board schematic nets

Connections to AM4372

waveforms observed in board (1ms/div)

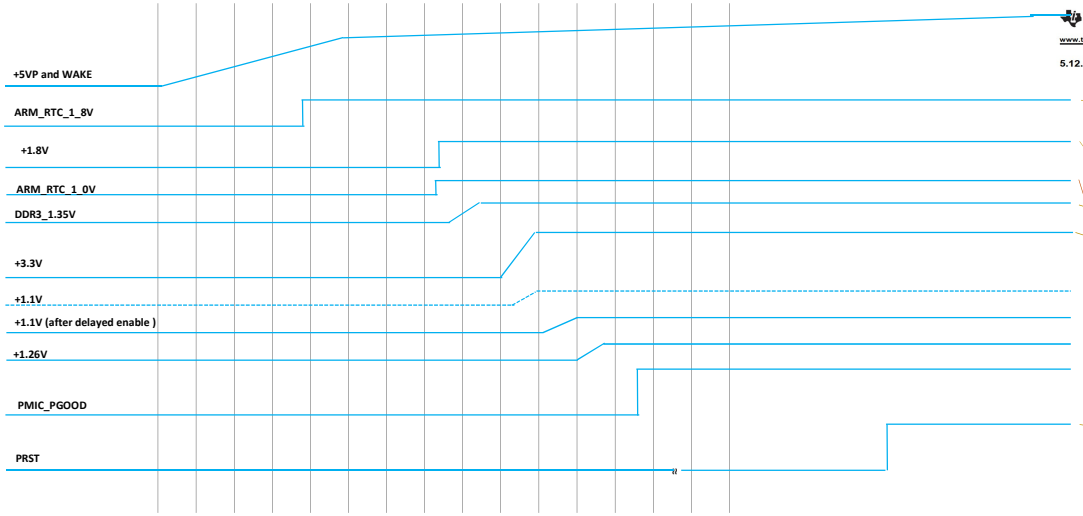
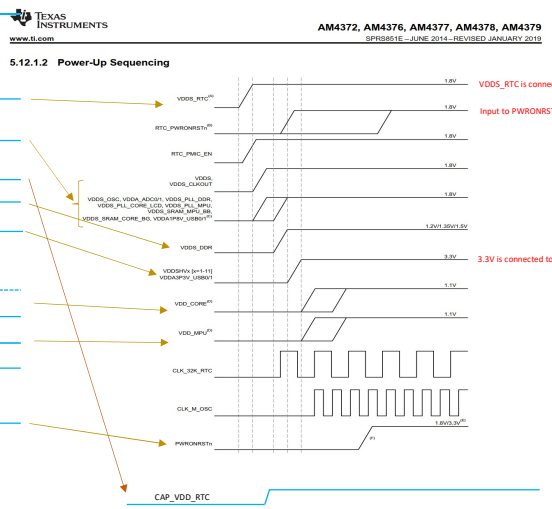
VDDS_RTC is conneced to ***RTC_KALDO_ENn*** in the board

Input to PWRONRSTn is level shifted and conneced to ***RTC_PWRONRSTn*** in the board

3.3V is connected to ***VDDS3P3V_IOLDO*** in the board

Initially observed that 1.1V is rising along with 3.3V. (Is it a problem ?)
Hence we added delay in enable of 1.1V so that the output starts rising only after 3.3V settles to final value.
